SSD-73603959

**RE: SUBMISSION TO SSD-73603959, UPA WAHROONGA SENIORS HOUSING**  
**Address: 1610, 1614-1634 Pacific Highway and 5 Munderah Street, Wahroonga**

### Ku-ring-gai Council's objection to SSD-73603959, UPA Wahroonga Seniors Housing at 1610, 1614-1634 Pacific Highway and 5 Munderah Street, Wahroonga

**Figure 3 – Extract from Ground Floor Plan of Building 6 indicating pedestrian access from the rear of the building**

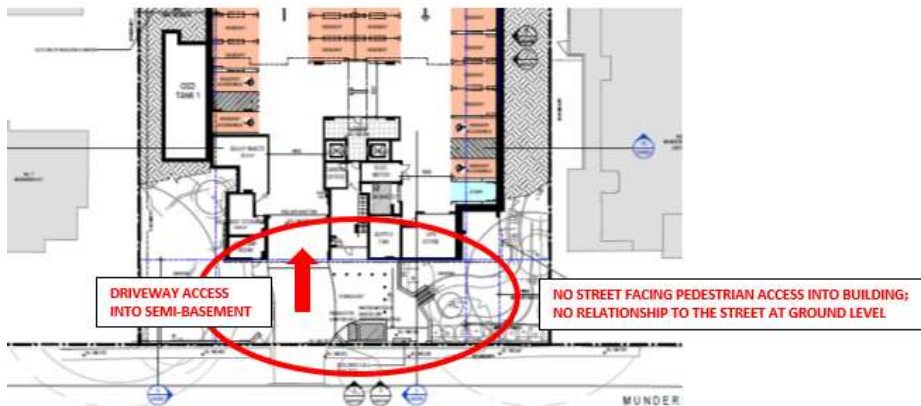
- iv. The entry foyer does not face Munderah Street, instead turning its back on the street to face the inside of the site, creating inconsistency in the streetscape.

- v. Consideration should be given to how Building 6 can better address Munderah Street, for example inclusion of an entry lobby facing the street and sinking the basement to relate the ground floor and its entry to the street.

**Figure 5 – Extract from photomontages looking north-west up Pacific Highway towards Buildings 4 and 3**

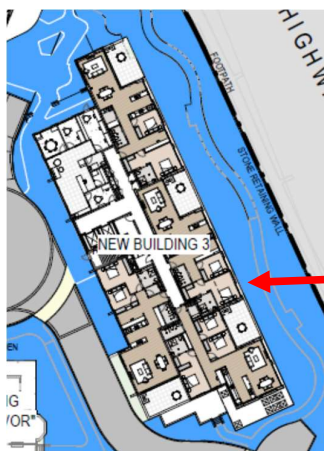
The north-eastern elevation of Building 3 is particularly long with only minimal recessed elements by way of winter gardens and window reveals. There is a strong vertical presence with Building 3, which is accentuated by the limited stepping back at the upper levels. The design of Building 3 should consider greater building articulation particularly in the way it presents to Pacific Highway to ensure a built form outcome that better respects the existing built form character along this section of Pacific Highway and to ensure consistency with Cl.1 (b) and (d) 'Built form and scale' of Schedule 8 of SEPP (Housing) 2021. This could be achieved through splitting this building into two and providing different modulation and finish treatments to that of Buildings 1 and 2 and provision of upper level built form step backs.

**BUILDING 3 HAS AN EXCESSIVELY LONG FAÇADE WITH LIMITED MODULATION TO REDUCE THE BULK, SCALE AND MASS OF THE BUILT FORM  
THE BUILDING WILL PRESENT IN A SIMILAR MANNER TO THE EXISTING REDLEAF BUILDING EXCEPT MORE IMPOSING DUE TO ITS DOUBLED HEIGHT**

**Figure 7 - An extract from the 1.45pm sun eye diagram. The area of concern is the northern balconies to the apartments within Block B of 1-3 Munderah Street**

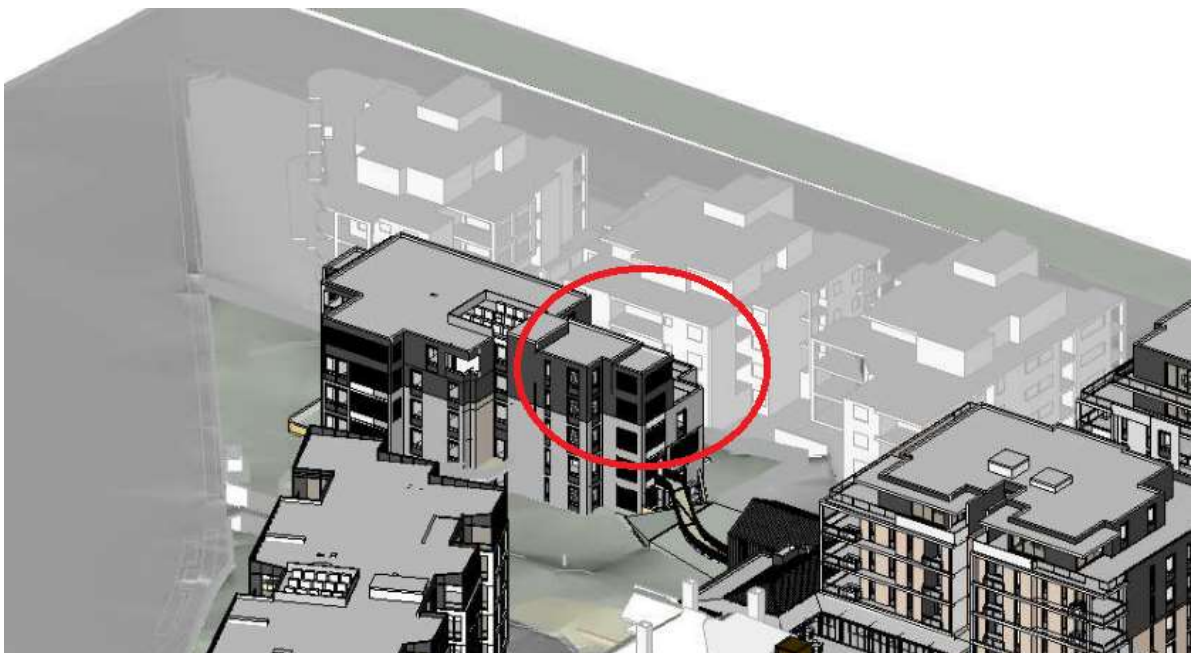
Council raises concerns with the overshadowing of the private open spaces of Block B within the adjoining development to the south at 1-3 Munderah Street. A review of the shadow diagrams would indicate that several of the private open space (balconies) of the northern units (Levels 1 and 2) of Block B within the adjoining development at 1-3 Munderah Street would not receive the required 2 hours of solar access between 9am and 3pm on 21 June (mid-winter) and therefore would be adversely impacted by the proposed development. This is inconsistent with the requirements of Cl.3(a) of Schedule 8 of SEPP (Housing) 2021 which states as follows:

This impact on solar access to the neighbouring property is largely due to the design and siting of proposed Building B.

**Figure 9 – Extract from Basement Plan indicating the areas of the basement that are of concern to Council**

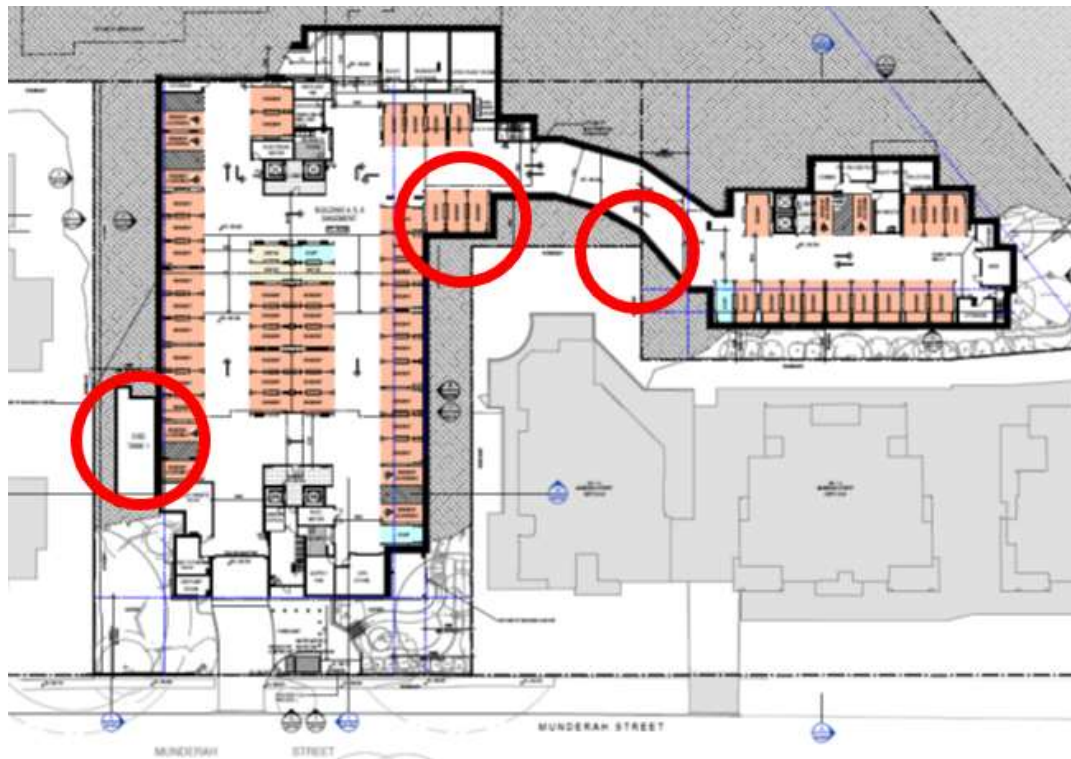
Council raises concerns with the proximity of basement excavation to the boundary line, circled in **Figures 9, 10A and 10B** below. Specific concerns are raised regarding the proximity of basement excavation to areas mapped as having biodiversity value (also circled in Figures below). In Council's opinion –

- The basement should sit directly under the building line to allow sufficient deep soil that can support tall tree planting in the side setbacks capable of buffering visual impacts to adjacent

- The OSD tank to the west of Building 6 is to be placed directly under the building footprint within the basement area.
- Consideration should be given to provision of a partial extra basement level to accommodate the subterranean works within the building footprint.

- The 6 metres wide ramp/underground passage connecting Building 6 and Building 4 carpark is not supported. It is understood that access into the basement of Building 4 is difficult, however, the width of the connecting underground roadway should be reduced to a single lane width utilising traffic signals to control directional movement. This will reduce excavation close to the boundary line and biodiversity areas.

**Figures 10A, B and C – Extracts indicating relationship of Buildings to Biodiversity Mapped Areas**

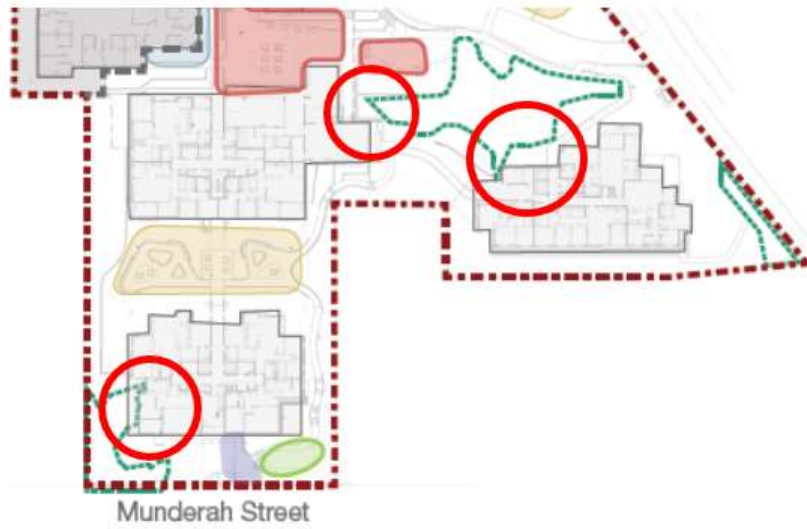
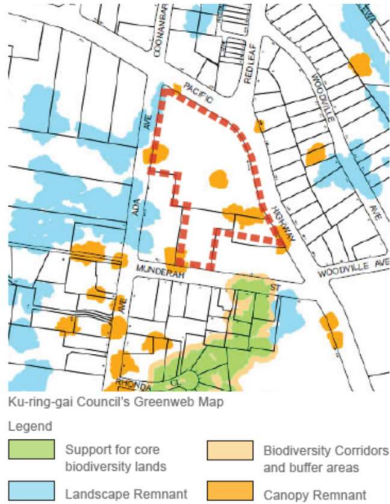
- It is unclear how the building footprint and landscape design protect the Biodiversity Protection area at the front setback. The building footprint appears to sit on top of the northern portion of the mapped area.

- The building front and side setbacks are to be increased to avoid overlap and impacts to the mapped Biodiversity Protection area. Pathways and hard stands are to be avoided within the mapped area.

No works are to occur in these areas except rehabilitation works as outlined in the VMP prepared for the site.

**Figure 12: Council's preferred construction access/egress (first preference)**

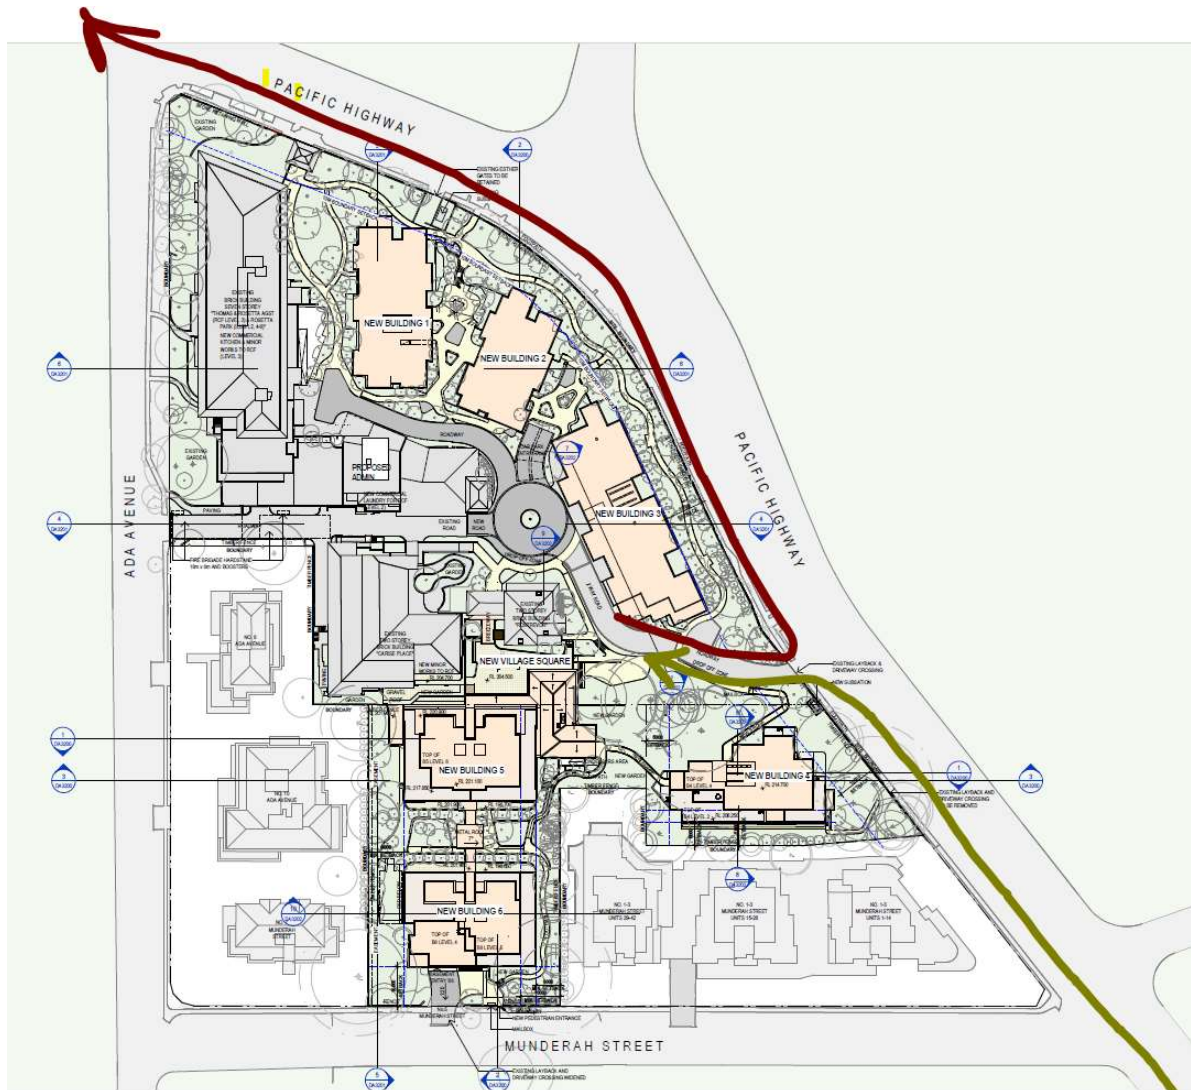
In order to protect the amenity of residents in Ada Avenue and Munderah Street and to minimise heavy vehicle activity around the Abbotsleigh Senior School frontage on Ada Avenue, it is requested that temporary construction access be provided on Pacific Highway frontage at the existing layback crossing and gate (see **Figure 12**). Vehicles exiting this construction will turn left onto Pacific Highway to head either further north, or to travel south (via NorthConnex).
